SUBJECT: AMENDMENT NO. 44 TO FACILITY OPERATING LICENSE NO. NPF-43:  
(TAC NO. 75279)

AMENDMENT TO FACILITY OPERATING LICENSE

Amendment No. 44  
License No. NPF-43

SAFETY EVALUATION BY THE OFFICE OF NUCLEAR REACTOR REGULATION  
RELATED TO AMENDMENT NO. 44 TO FACILITY OPERATING LICENSE NO. NPF-43

FIGURE 3.2.1-3

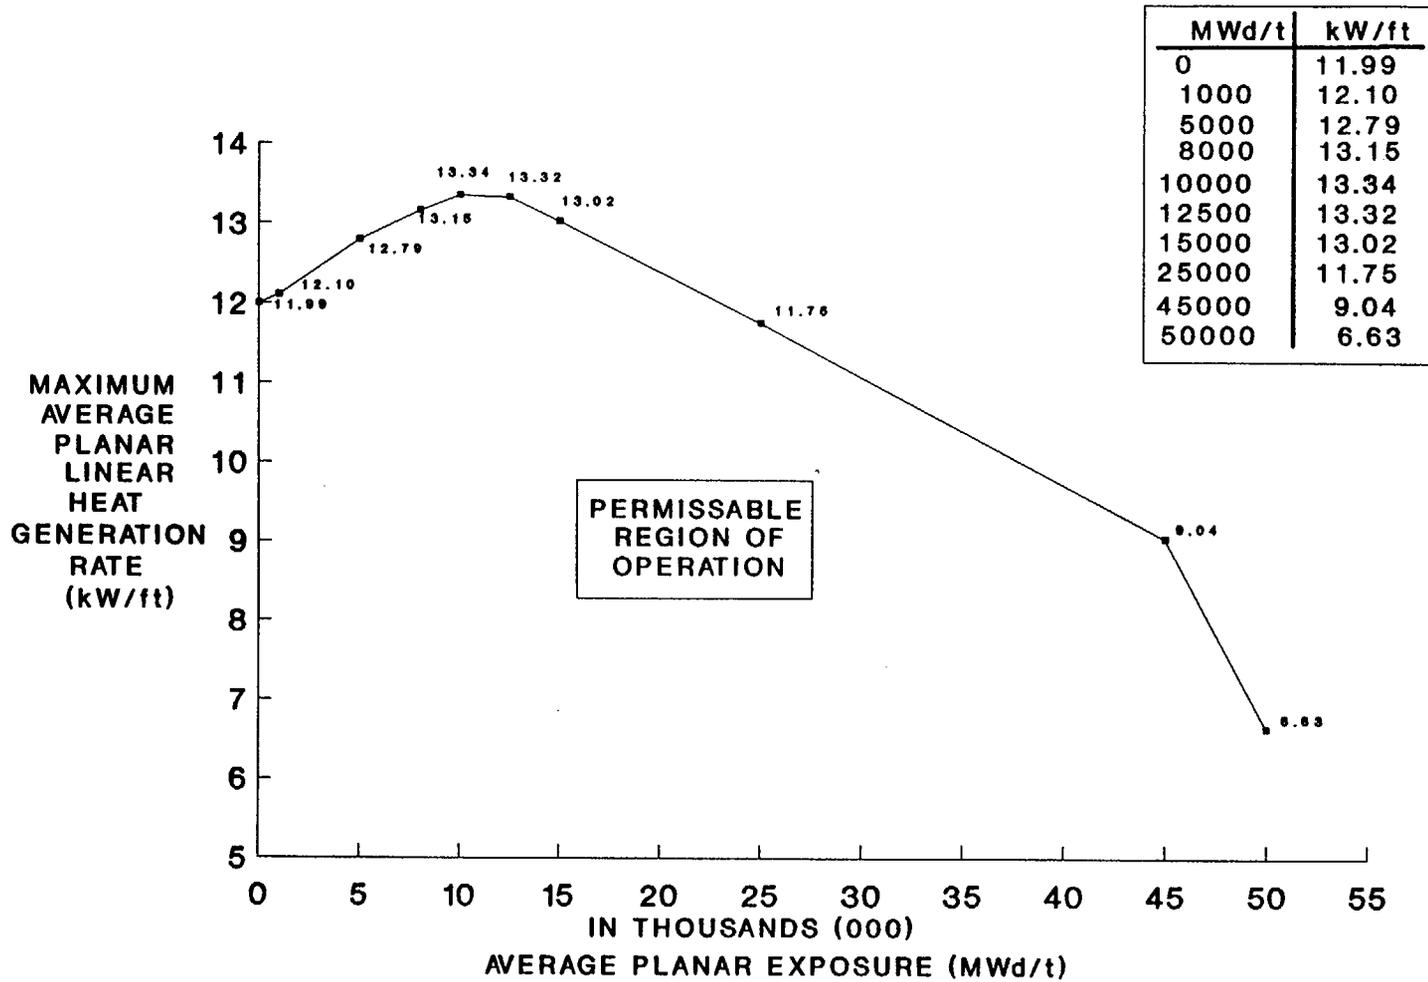
In both figures, one point specified for the joining of two line segments was not graphically plotted consistent with the tabular information. In both figures, the point tabularly indicated to be associated with 12,500 MWD/t was graphically plotted at 12,000 MWD/t. Further, the heading for the MWD/t column in both figures is incorrectly given as "MWD/" rather than the correct units of "MWD/t."

The November 16, 1989 submittal contained revised Figures 3.2.1-3 and 3.2.1-4 with the graphs replotted to correctly indicate the RLS information. A corrected heading for the Average Planar Exposure column of the table is also included.

**FIGURE 3.2.3-1**

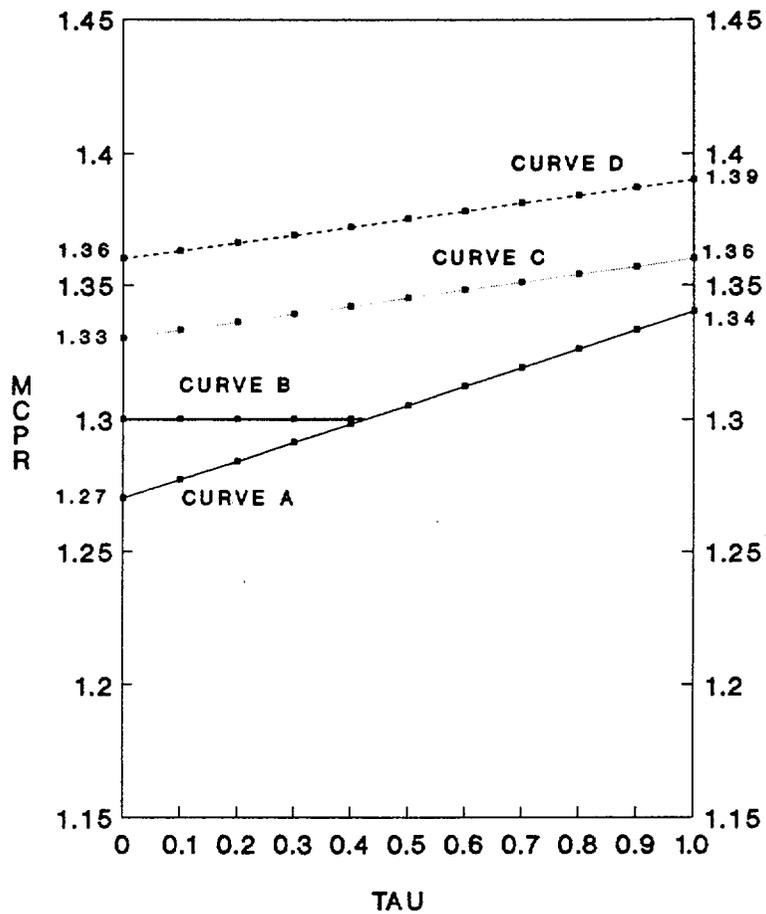
The nomenclature associated with Curve C and Curve D, which appears on each of these figures, was found to be unclear as proposed in the April 3, 1989, application and as issued in Amendment No. 42. The nomenclature is proposed to more clearly indicate which equipment is assumed to be out-of-service for the two curves. Previously, the terminology "without a piece of equipment" was used to mean "with the equipment out-of-service." The proposal is strictly editorial and makes no change to the intent or application of the curves.

On Figure 3.2.3-1, the MCPR value for tau equal to 1.0 for the merged Curve A and B is not given on the figure. This point corresponds to a MCPR of 1.32. This value is the "Option A" most limiting pressurization event for the exposure range "BOC2 to EOC2 - 2000 MWD/St" located on RLS page 13.

FIGURE 3.2.3-1A

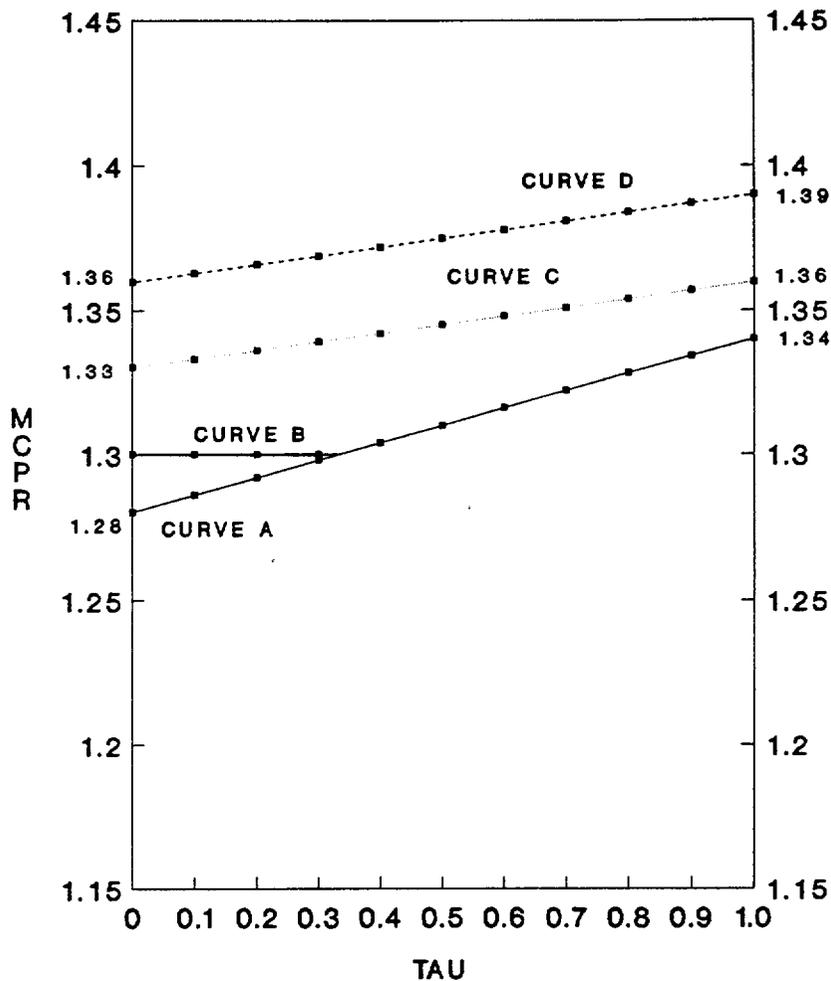
On Figures 3.2.3-1A and 3.2.3-1B a value of less than 1.30 appears to be indicated for a portion of Curve B which should be a constant 1.30. This occurs near the point where Curves A and B join. This proposal corrects Curve B for these two figures by indicating the correct value of 1.30 for the constant MCPR segments of Curve B.

FIGURE 3.2.3-2

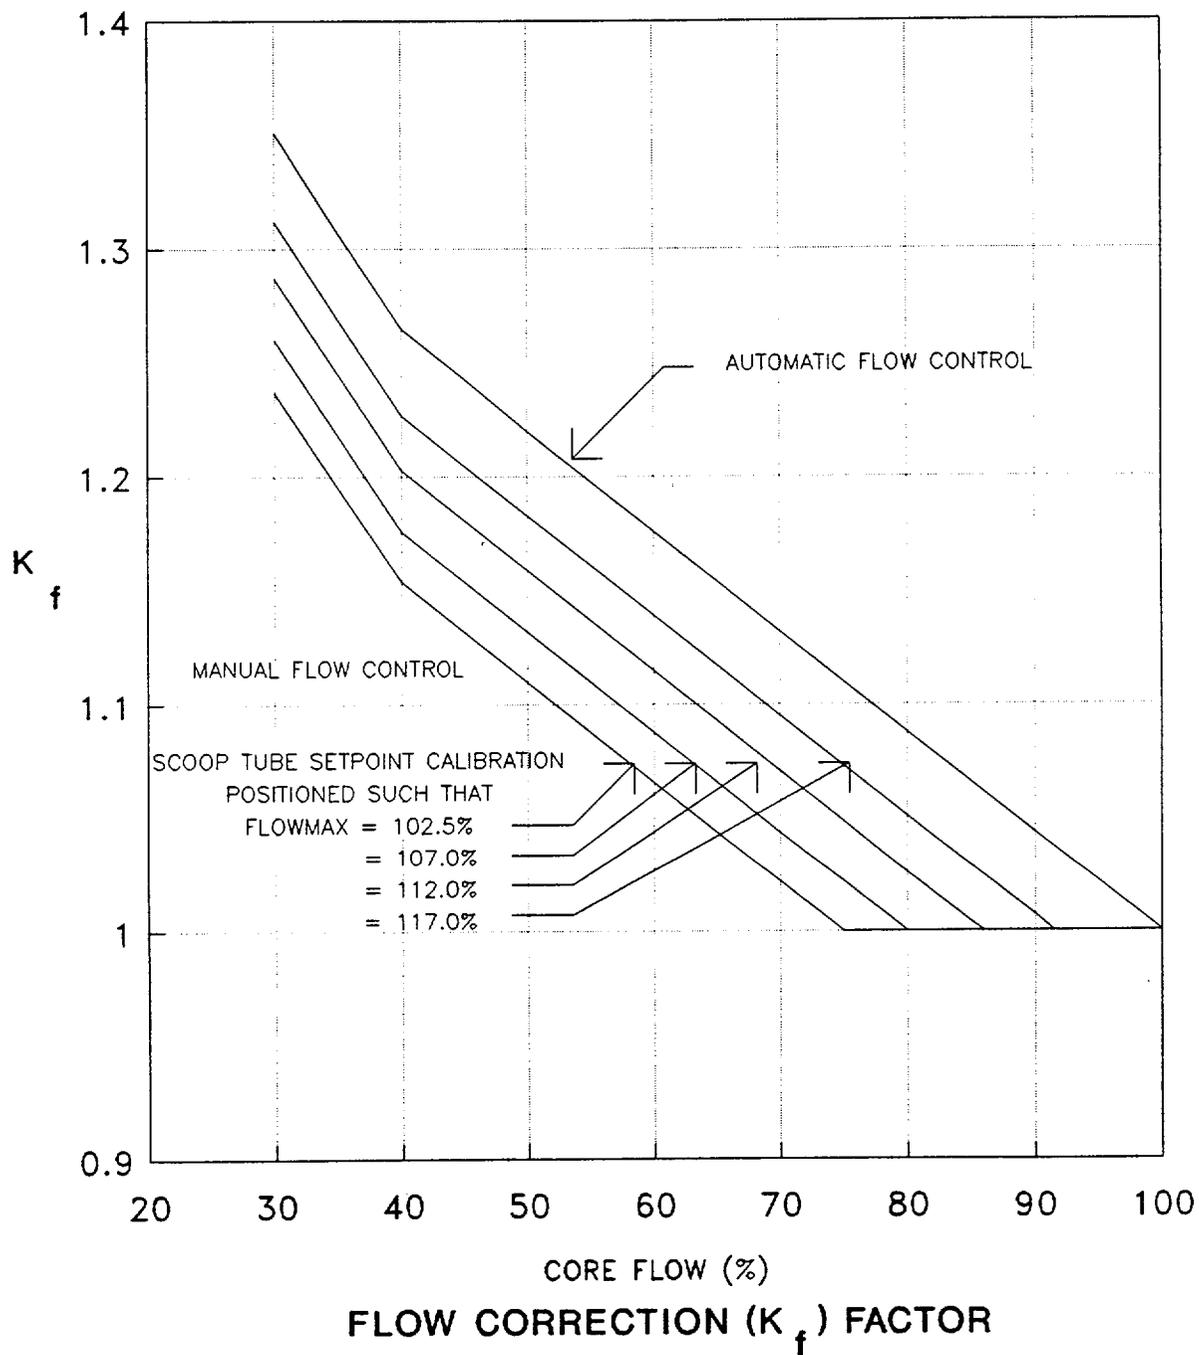
The amendment revises the TS Figure 3.2.3-2, Flow Correction ( $K_f$ ) Factor. The figure was part of a previous license amendment request dated April 3, 1989, and issued by the NRC as Amendment No. 42 to the Fermi-2 Operating License and was recently found to be in error. Further review of other figures issued in Amendment 42 determined that five other figures submitted should be modified to more clearly show the limits they impose upon plant operation. In addition, some administrative or typographical errors were found in the designation of the fuel bundle types in Specification 3.2.4 and in the referencing of new figures in Specification 4.2.3.1. Minor corrections to the Bases were also found to be necessary.

As discussed above under Introduction, these figures were incorrectly drawn in the preparation of the April 3, 1989, application. The sole change to these figures is to provide the correct curves.

The sole purpose of the proposed change is to correct an administrative error made in the preparation of the April 3, 1989, application. No change to the underlying accident analysis has been made.
